# HYDROGEOLOGICAL ASSESSMENT OF THE PROPOSED 401 WATER QUALITY CERTIFICATION TO BE ISSUED FOR THE ATLANTIC COASTAL PIPELINE PROJECT, VIRGINIA, BY THE VIRGINIA STATE WATER CONTROL BOARD

Prepared by Pamela C. Dodds, Ph.D., Licensed Professional Geologist  
Prepared for **Dominion Pipeline Monitoring Coalition**

August 17, 2017

**Figure 1.3-1** – ERM’s drainage area 132 for the area encompassing the watershed extending from MP 93.0 to MP 93.7, excerpted from ACP’s Appendix X.

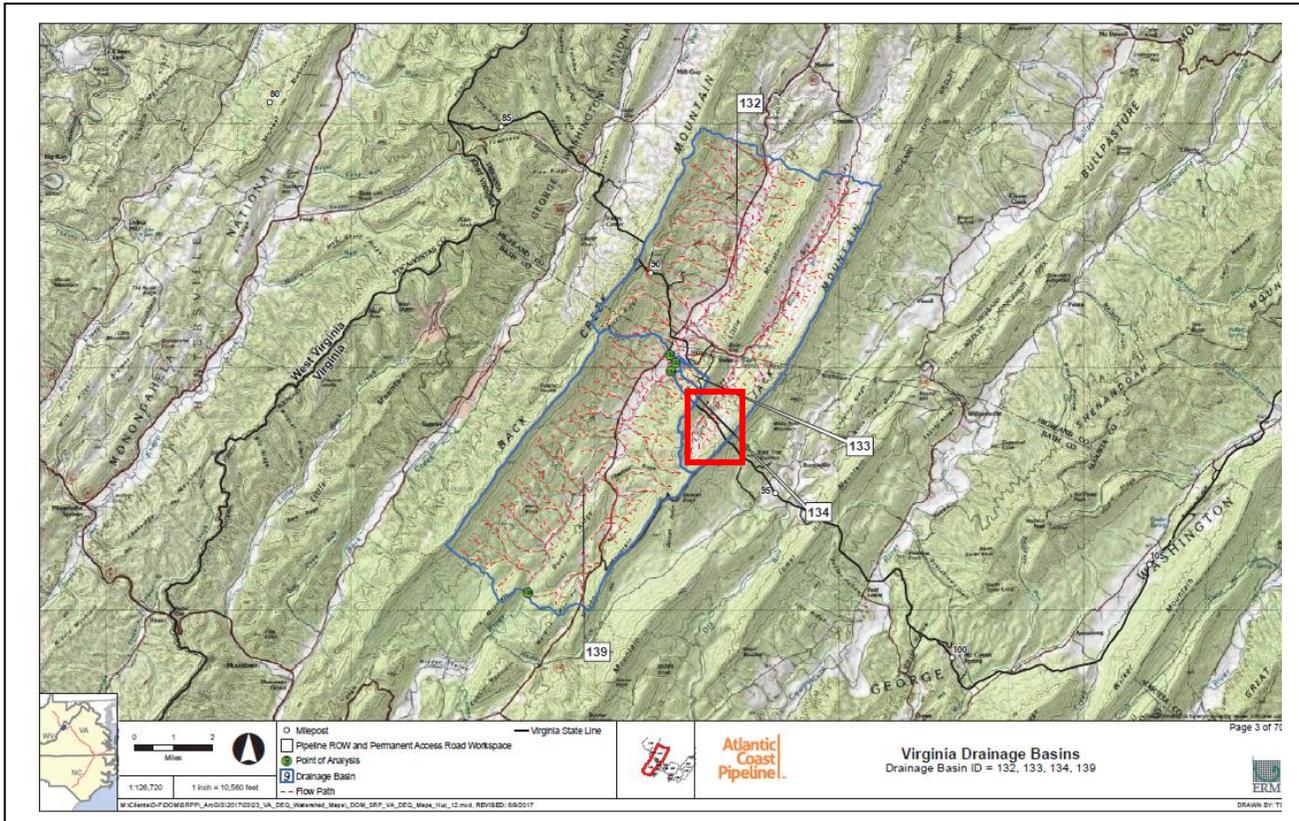
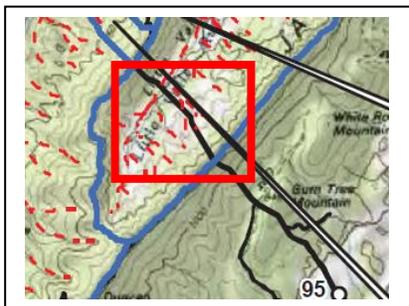
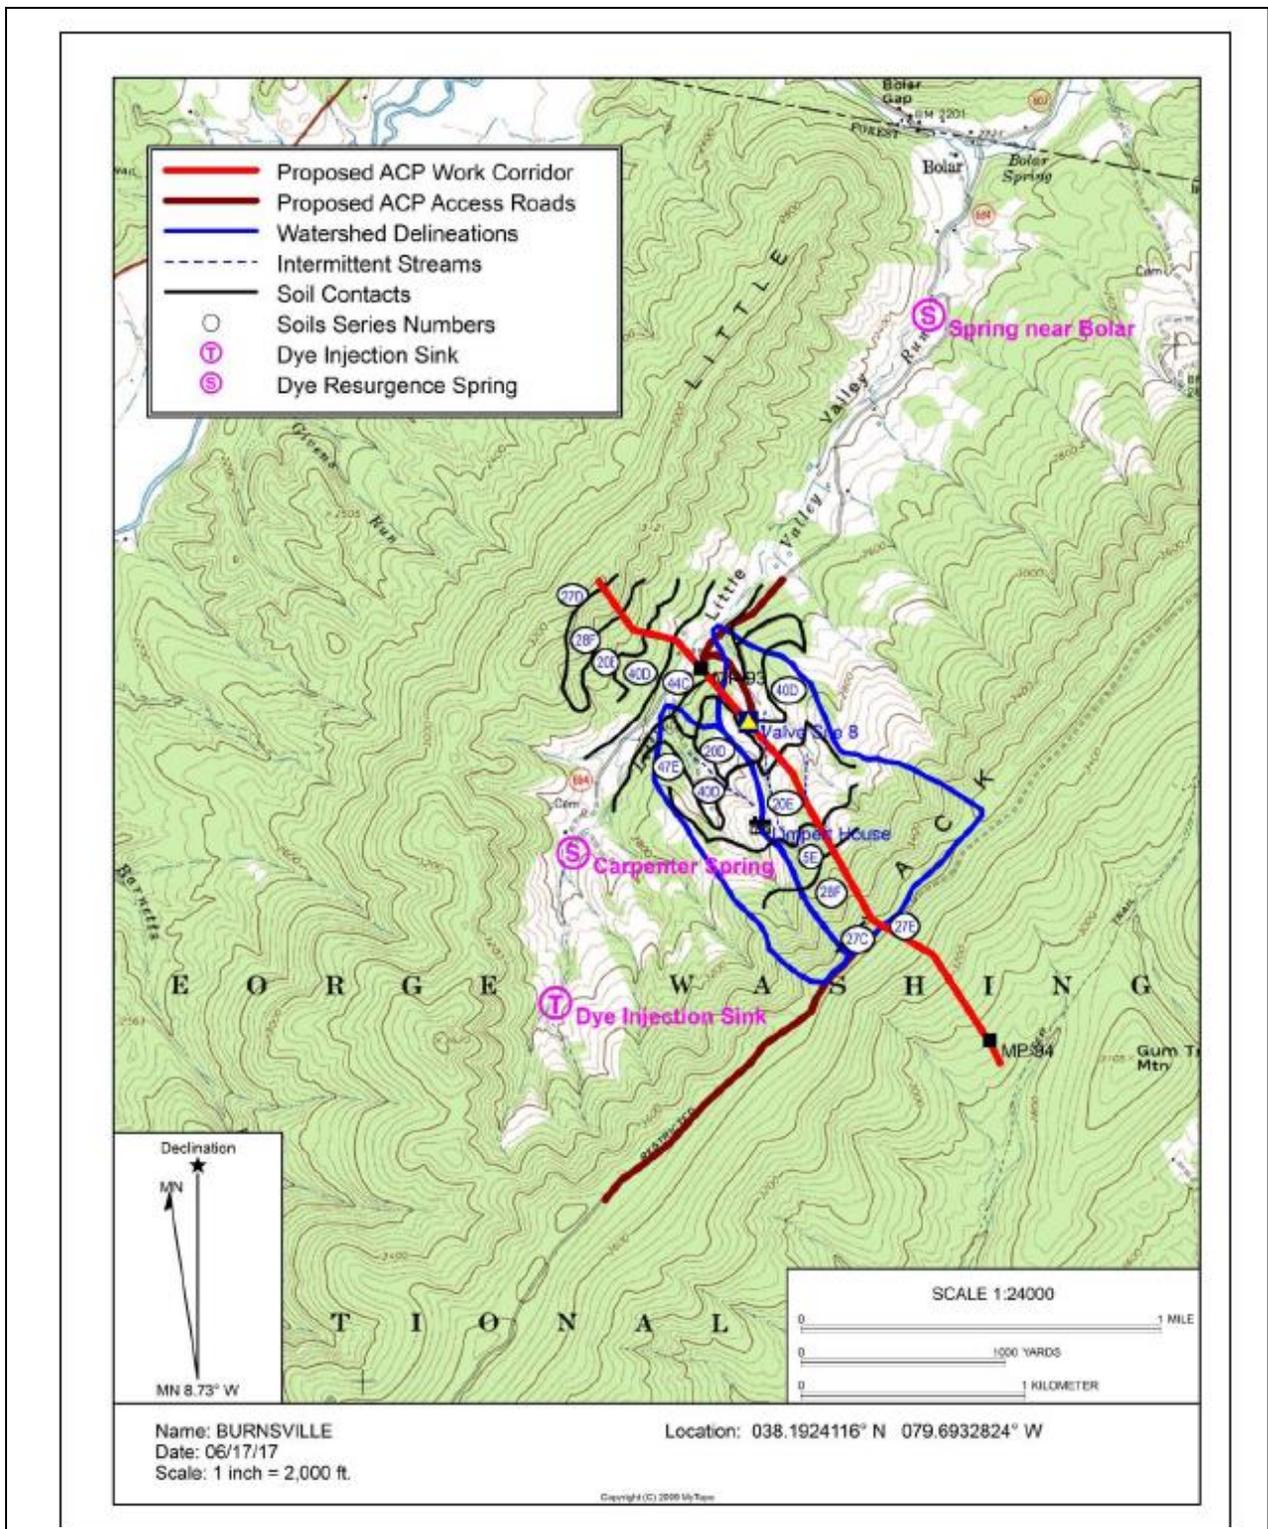
The drainage areas delineated by Environmental Resources Management (ERM) for DETI are provided in the report, “Appendix X – Access Road and Right-of-Way Post-Construction Stormwater Management Evaluation Report, *Atlantic Coast Pipeline*”, dated June 12, 2017, for the stated intent of addressing “compliance of ACP with Virginia’s water quantity and quality criteria as set forth in 9VAC25-870-66 and 9VAC25-870-63, respectively, and related Virginia Department of Environmental Quality (VDEQ) guidance.” ERM delineated 170 drainage basins within the entire area proposed for the ACP construction in Virginia. The drainage basins used for water quantity calculations range from 36 acres to 84,092 acres. Only 20 of the drainage basin areas are less than or slightly greater than 200 acres, which is the typical size for meaningful stormwater discharge calculations. The larger delineated drainage basins extend far beyond the watershed of upland first order high gradient streams that will be impacted by ACP construction activities. Ground cover estimates and stormwater calculations for watersheds exceeding the area of the upland first order streams, second order streams, and third order streams obscure the impacts to functions within the smaller watersheds. For example, the impervious area created by the proposed ACP work corridor and

access roads constitutes a larger percentage of impervious ground cover in the watershed of approximately 185 acres for the upland first order high gradient stream (tributary to Little Valley Run) extending from approximately Mile Post (MP) 93.0 to approximately MP 93.7 than for the watershed area of 19,215 acres delineated by ERM for ACP. **Figure 1.3-1**, which depicts drainage area 132 for the area encompassing the watershed extending from MP 93.0 to MP 93.7, is excerpted from ACP's Appendix X. **Figure 1.3-2** highlights the small area of the upland first order unnamed tributary (UNT) stream within the ACP drainage area 132. **Figure 1.3-3** provides the delineation of the upland first order UNT stream impacted by the proposed ACP construction.

As shown in **Figure 1.3-1**, **Figure 1.3-2**, and **Figure 1.3-3**, the drainage area (or watershed) for the upland first order stream UNT to Little Valley Run is approximately 185 acres, which is far less than the 19,251-acre ERM delineated drainage area that includes the upland first order stream UNT to Little Valley Run. Calculations using the Rational Method and the TR-55 Method were performed by Dan Shaffer (Spatial Analyst, Dominion Pipeline Monitoring Coalition, personal communication) and Ari Daniels, EIT (Center for Watershed Protection, personal communication), respectively, to determine the 24-hour 2-year peak stormwater discharges for 4 upland first order streams, as summarized in **Table 1.4-1**. Ground cover coefficients used in the Rational Method included those for forest, pasture, and impervious (ACP construction areas). Ground cover coefficients used in the TR-55 Method included those for forest, pasture, and, for the ACP construction areas, brush, open space, and gravel road. The Virginia Stormwater Management Handbook (VSMH), 2013, states that: “When soil is disturbed by grading, stockpiling, and heavy equipment traffic, the soil becomes compacted, structure is lost and porosity decreases. When this happens, the soil’s ability to take in water (permeability) is substantially reduced and surface runoff increases.... The result is a surface that is *functionally impervious* because the soil’s permeability is so greatly reduced.” However, ERM states in ACP Appendix X that “all areas categorized as Forest within the pipeline permanent and temporary ROW will be converted to the “Shrub land cover category”. In **Table 1.4-1**, the TR-55 Method peak stormwater discharges are based on ground cover coefficients similar to those used by ERM in their TR-55 stormwater calculations. According to VSMH, the use of ground cover coefficients reflecting more pervious conditions is not accurate; however, the TR-55 method results in **Table 1.4-1** are provided as a comparison, using more accurate drainage area sizes (**Figure 1.3-1** through **Figure 1.3-3** and **Figure 1.4-1** through **Figure 1.4-9**) and more pervious ground cover coefficients.

**Figure 1.5-3** – ACP typical section demonstrating removal of elevated side slope areas along the proposed ACP construction areas to create level work areas.

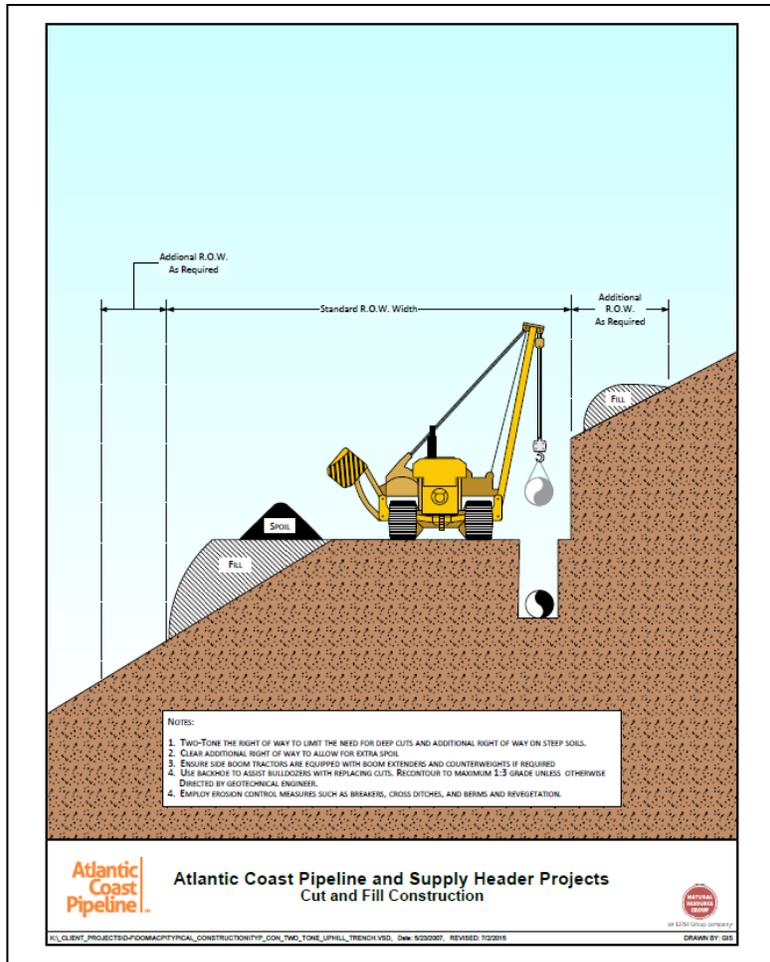
**Figure 1.5-3** is excerpted from ACP typical construction diagrams, showing the procedure for side slope construction. Water from seeps and springs encountered during this procedure will be directed onto the ground surface.
